May 4, 2022

City of Aurora
Ariana Muca
15151 E. Alameda Parkway, Suite 2000
Aurora, Colorado 80012

Re: Metro Center Parcel B: ISP & Final Plat (#1557299) / First Review Comment Response

C4

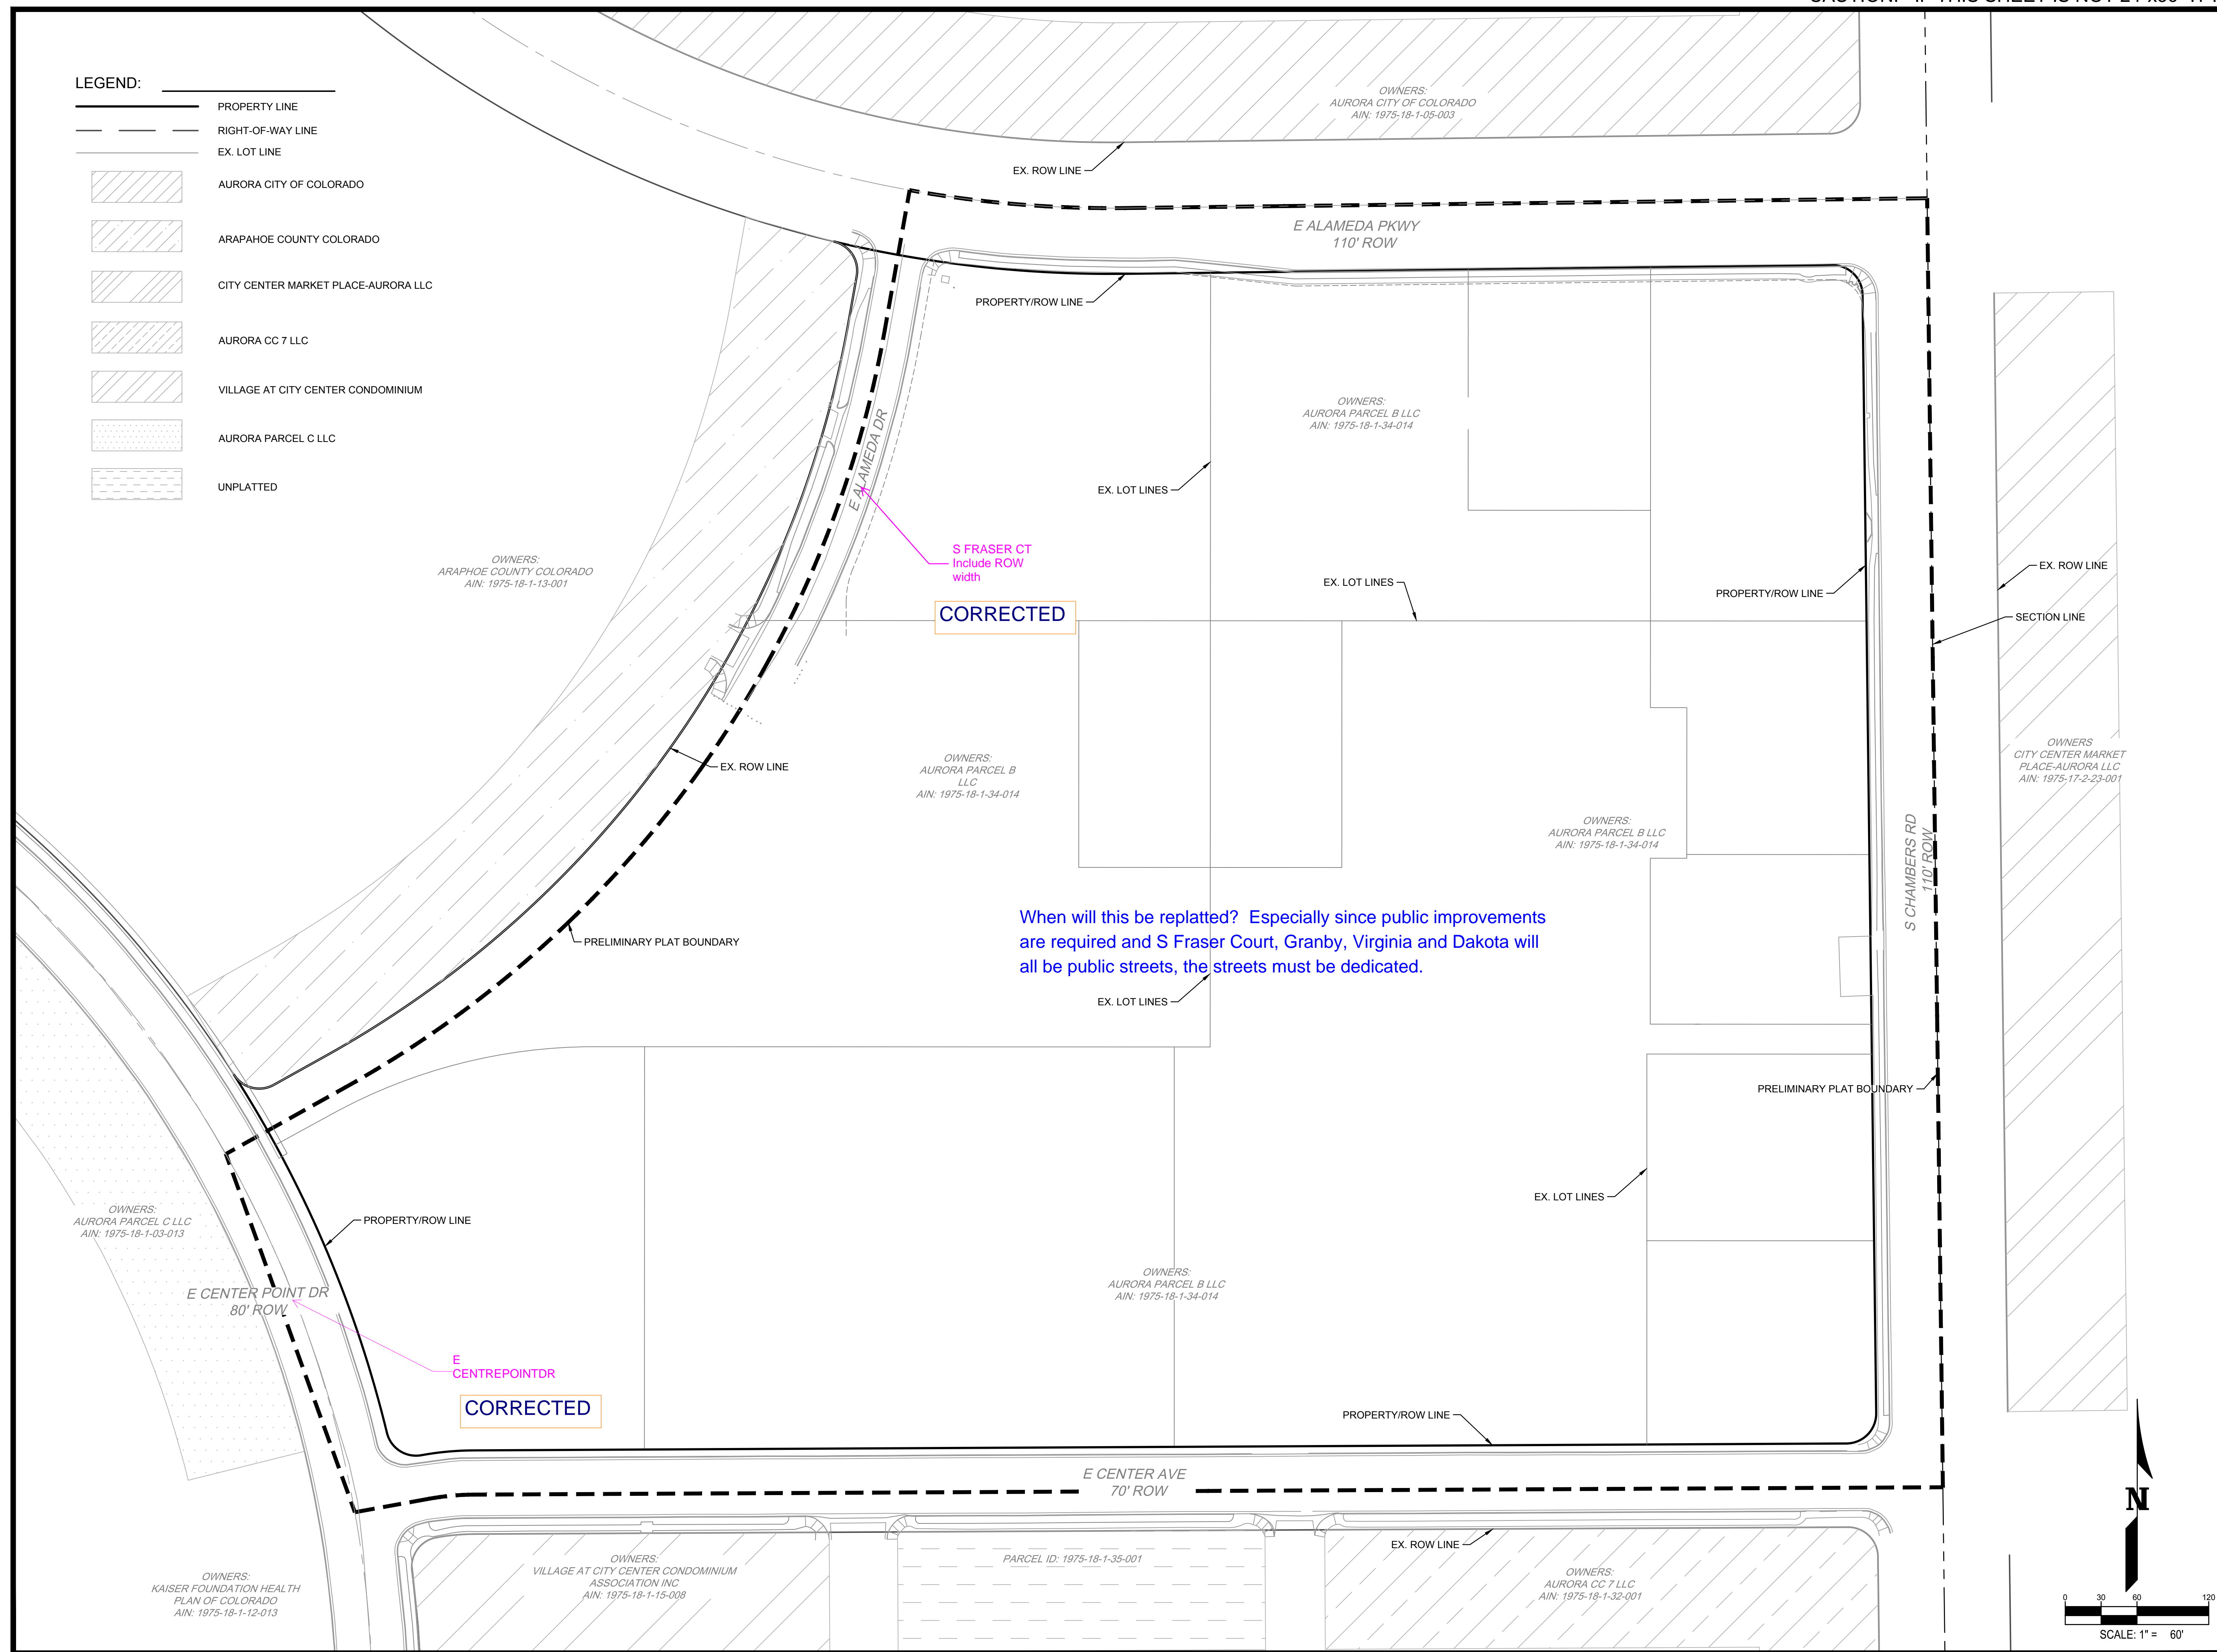
Replat to dedicate the streets as illustrated in the Master Plan.

Show dimensions, bearings, and curve data. This data must match the recorded or proposed subdivision plat information (typical).

Show and label all proposed easements (including fire lanes) and existing easements which are not going to be released (typical

Court be dedicated? No plan has been submitted. Please advise.

CORRECTED

CORRECTED

Easement labeled
per comment

CORRECTED

C5

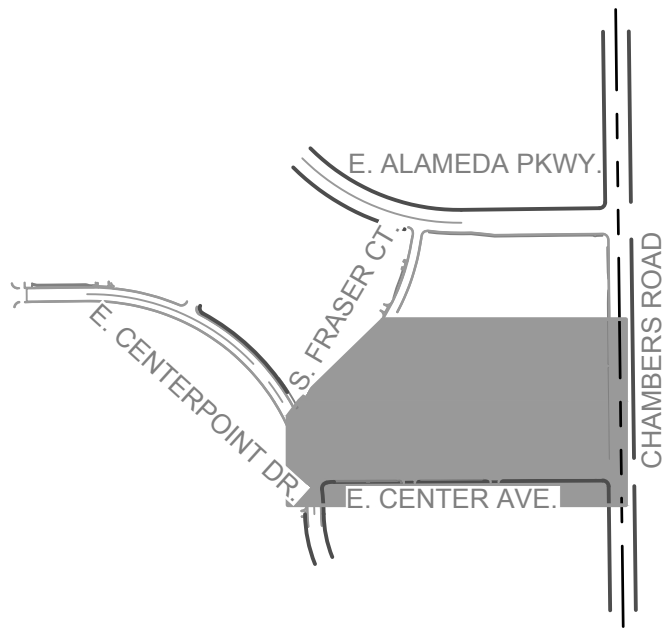
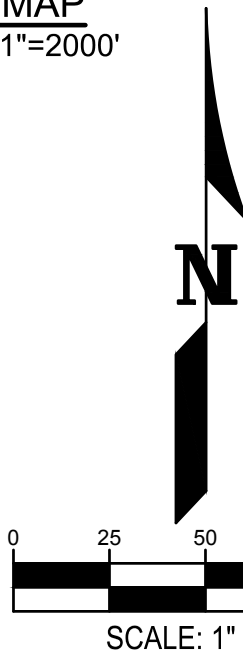
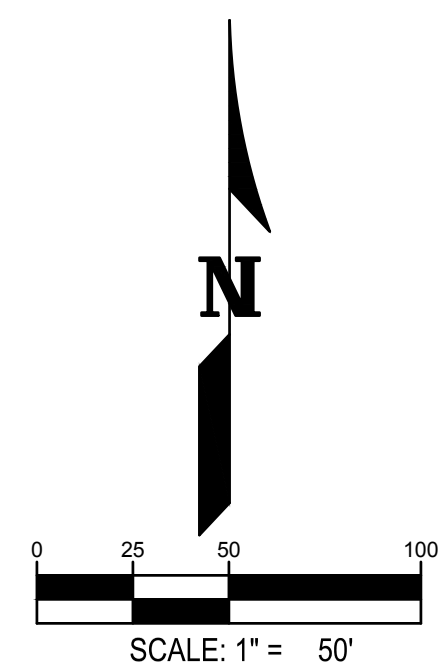
Replat to dedicate the streets as illustrated
in the Master Plan.

Show and label all proposed easements
(including fire lanes) and existing easements
which are not going to be released (typical)

Show dimensions,
bearings, and curve data.
This data must match the
recorded or proposed
subdivision plat information
(typical).

CORRECT

EASEMENT
CALL ADDED

Dimensions, bearings, and
curve data have been labeled
on this plan per comment.

SHEET
C8

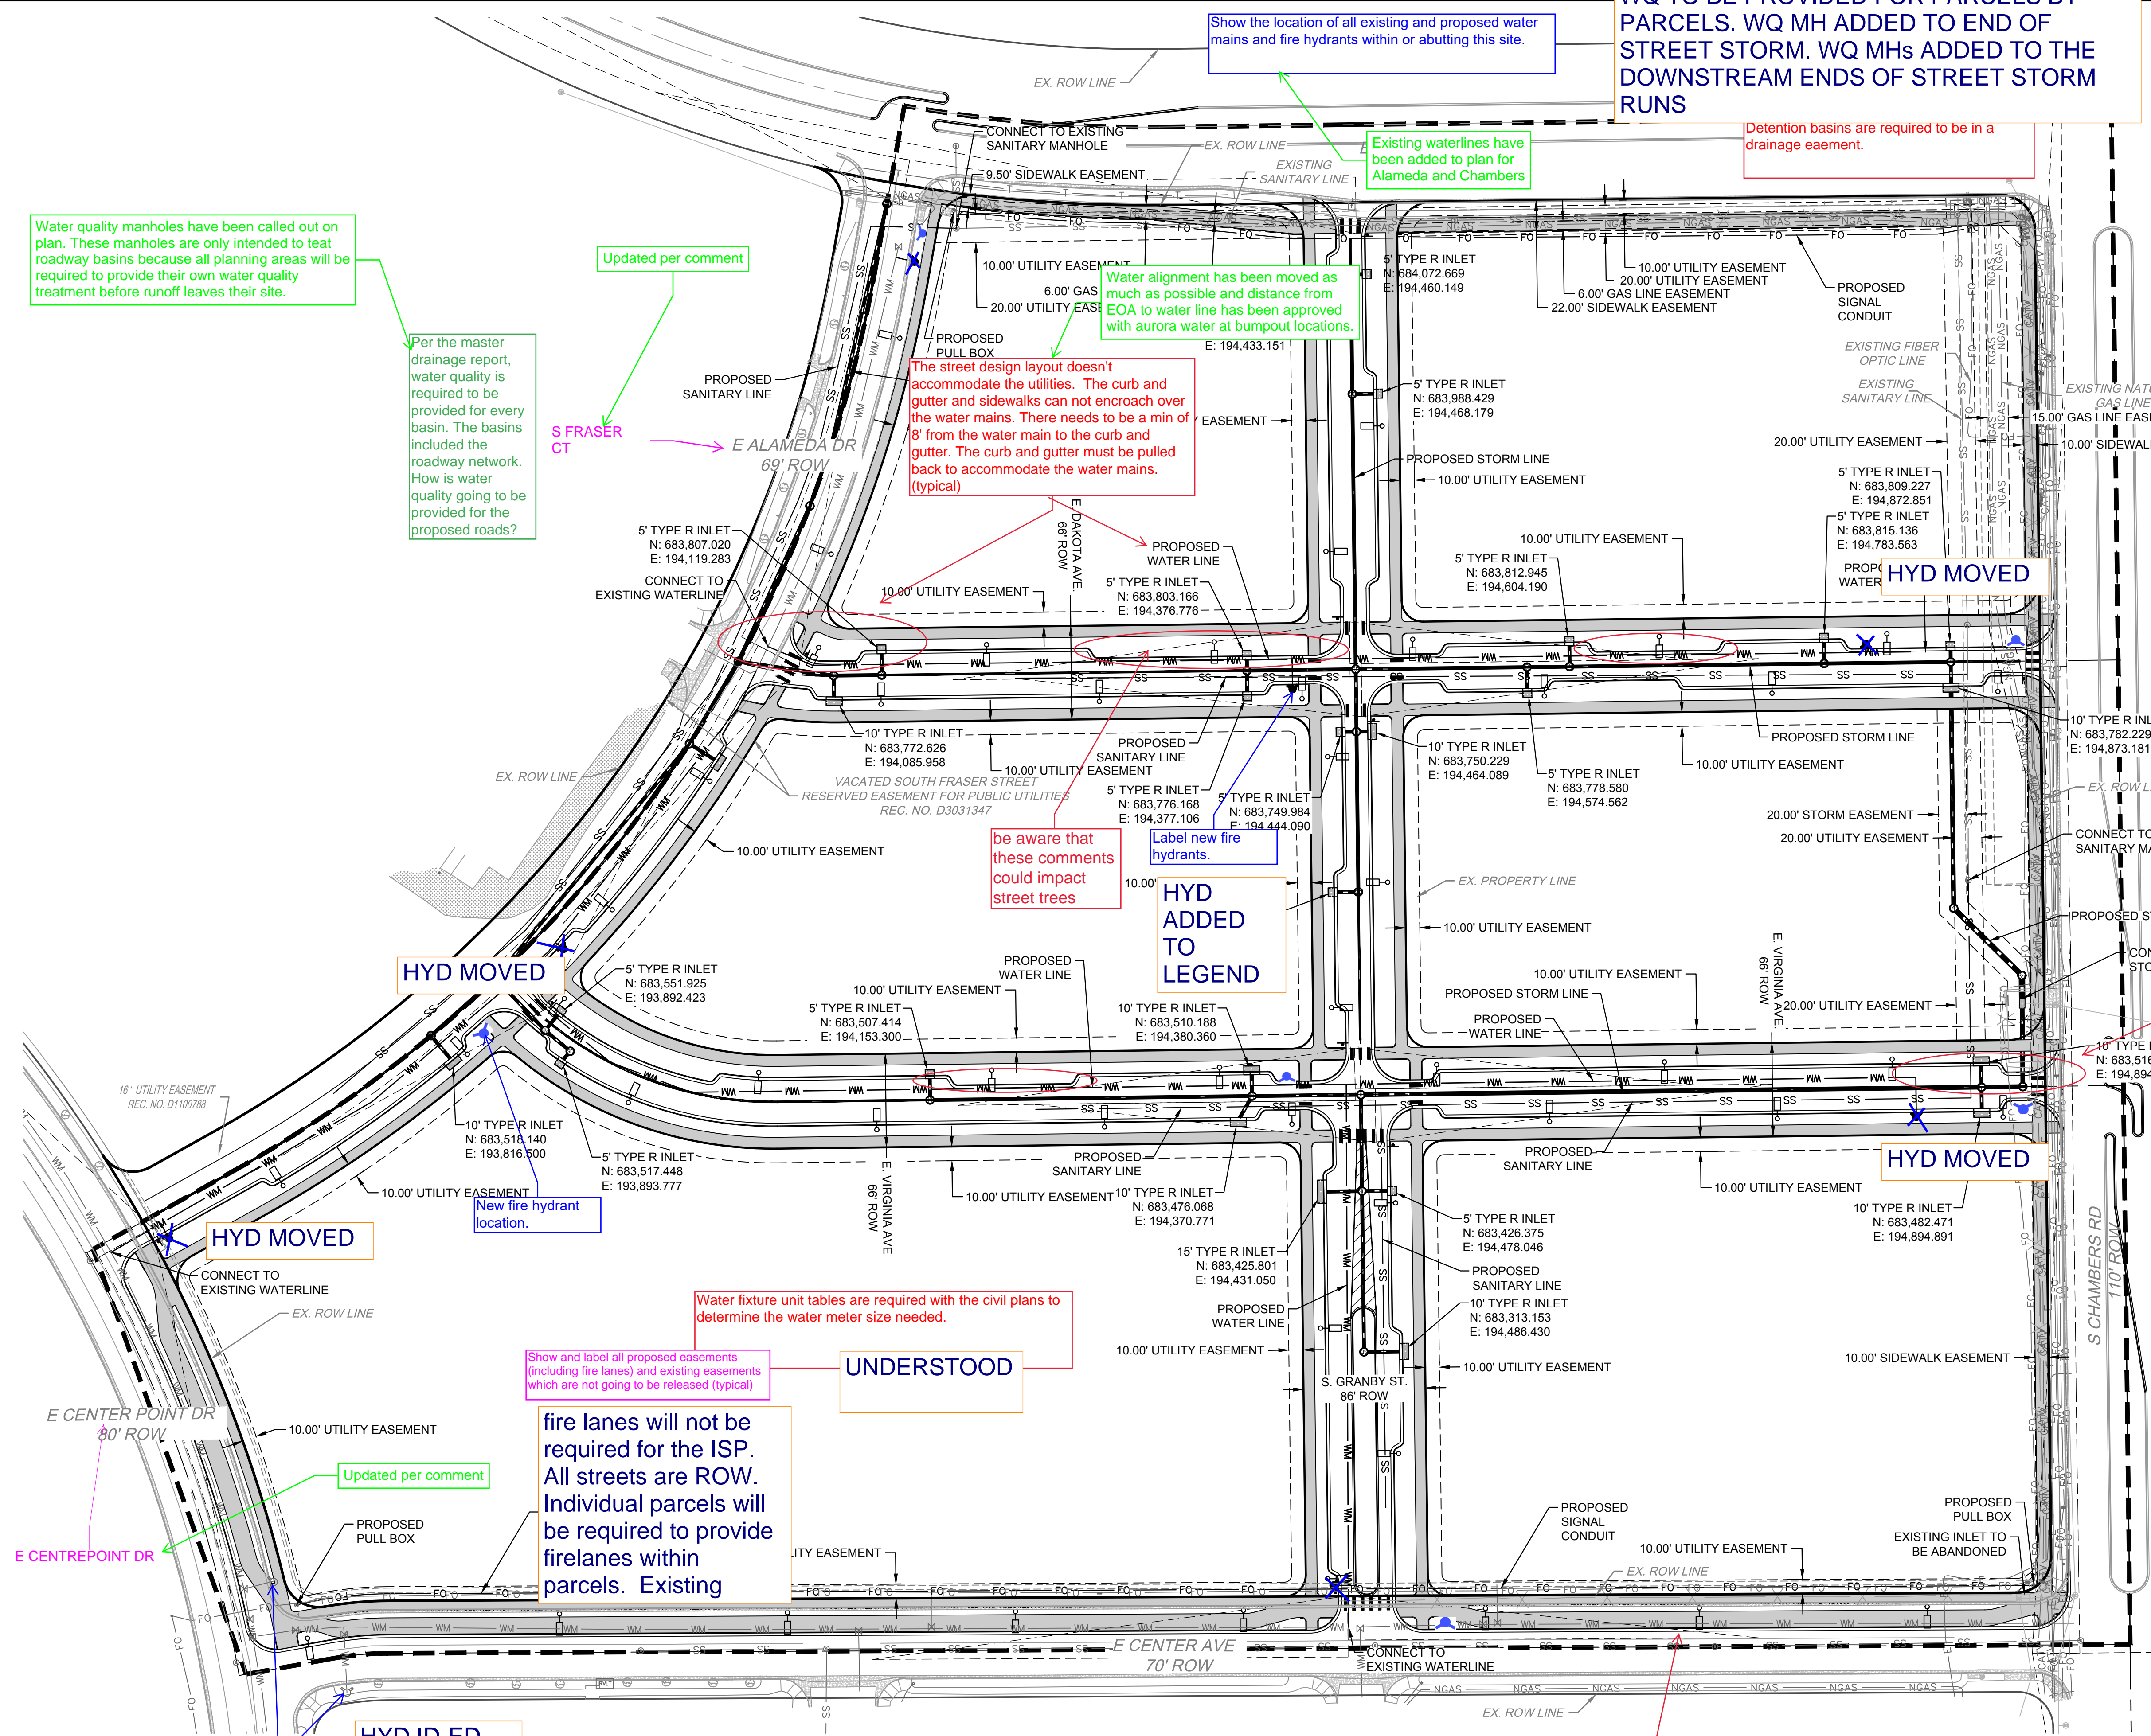
Show new fire hydrant symbol in legend.

Show and label all proposed easements (including fire lanes) and existing easements which are not going to be released (typical)

Water fixture unit tables are required with the civil plans to determine the water meter size needed.

Show the location of all existing and proposed water mains and fire hydrants within or abutting this site.

CORRECTED

Connection to water in Chambers has been shown per comment.

fire lanes will not be required for the ISP. All streets are ROW. Individual parcels will be required to provide firelanes within parcels. Existing

HYD
ADDED
TO
LEGEND

Existing waterlines have been added to plan for Alameda and Chambers

Water quality manholes have been called out on plan. These manholes are only intended to treat roadway basins because all planning areas will be required to provide their own water quality treatment before runoff leaves their site.
